Form 3160-3 (June 2015)			OMB No	APPROVED 0. 1004-0137 nuary 31, 2018		
UNITED STATES		nuary 51, 2018				
DEPARTMENT OF THE I BUREAU OF LAND MAN			5. Lease Serial No. NMNM102034			
APPLICATION FOR PERMIT TO D			6. If Indian, Allotee or Tribe Name			
1a. Type of work:   Image: Constraint of the second seco	EENTER		7. If Unit or CA Agreement, Name and No.			
1b. Type of Well: ✓ Oil Well Gas Well O	ther		8. Lease Name and Well No.			
1c. Type of Completion:   Hydraulic Fracturing	HONEY BUN 6 FE					
			710H

Eddy County, NM (NAD 83 NME) Honey Bun 6 Fed Com #710H

## COA

Proposed Wellbore Design A KB: 3,300' GL: 3,275'

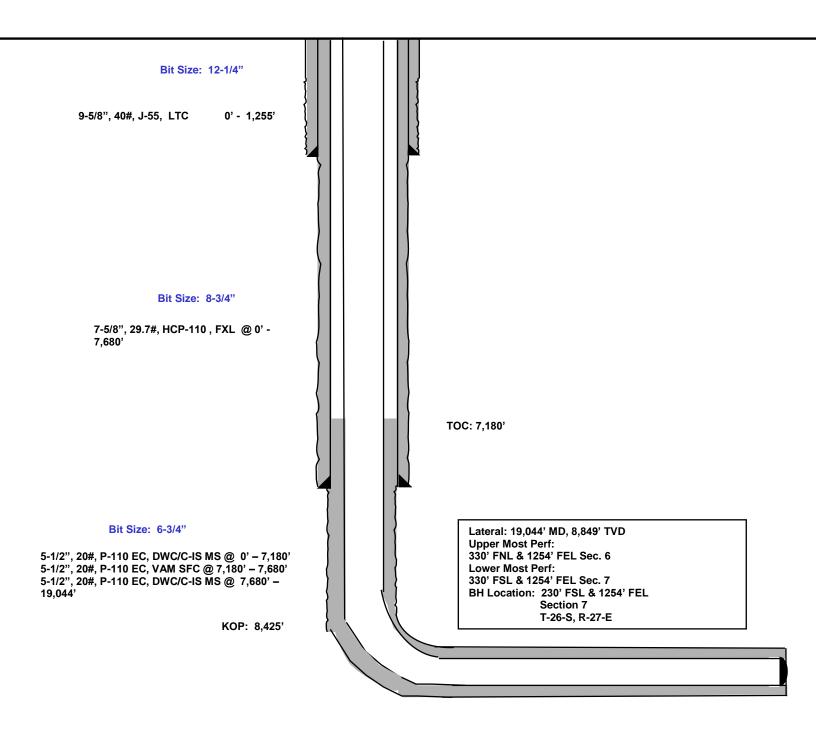
Operator is only approved for Design A. Design B is not to be utilized. If Design B is needed or any other change, please submit a NOI sundry to make the changes.

Operator has proposed to pump down 9-5/8" X 7-5/8" annulus after primary cementing stage. <u>Operator must run Echo-meter to verify Cement Slurry/Fluid top in the annulus Or operator shall run a CBL from TD of the 7-5/8" casing to surface after the second stage BH to verify TOC.</u>

- 3. The minimum required fill of cement behind the 5-1/2 inch production casing is:
  - Cement should tie-back at least **200 feet** into previous casing string due to operator not meeting casing clearance requirement per 43 CFR 3170. Operator shall provide method of verification.
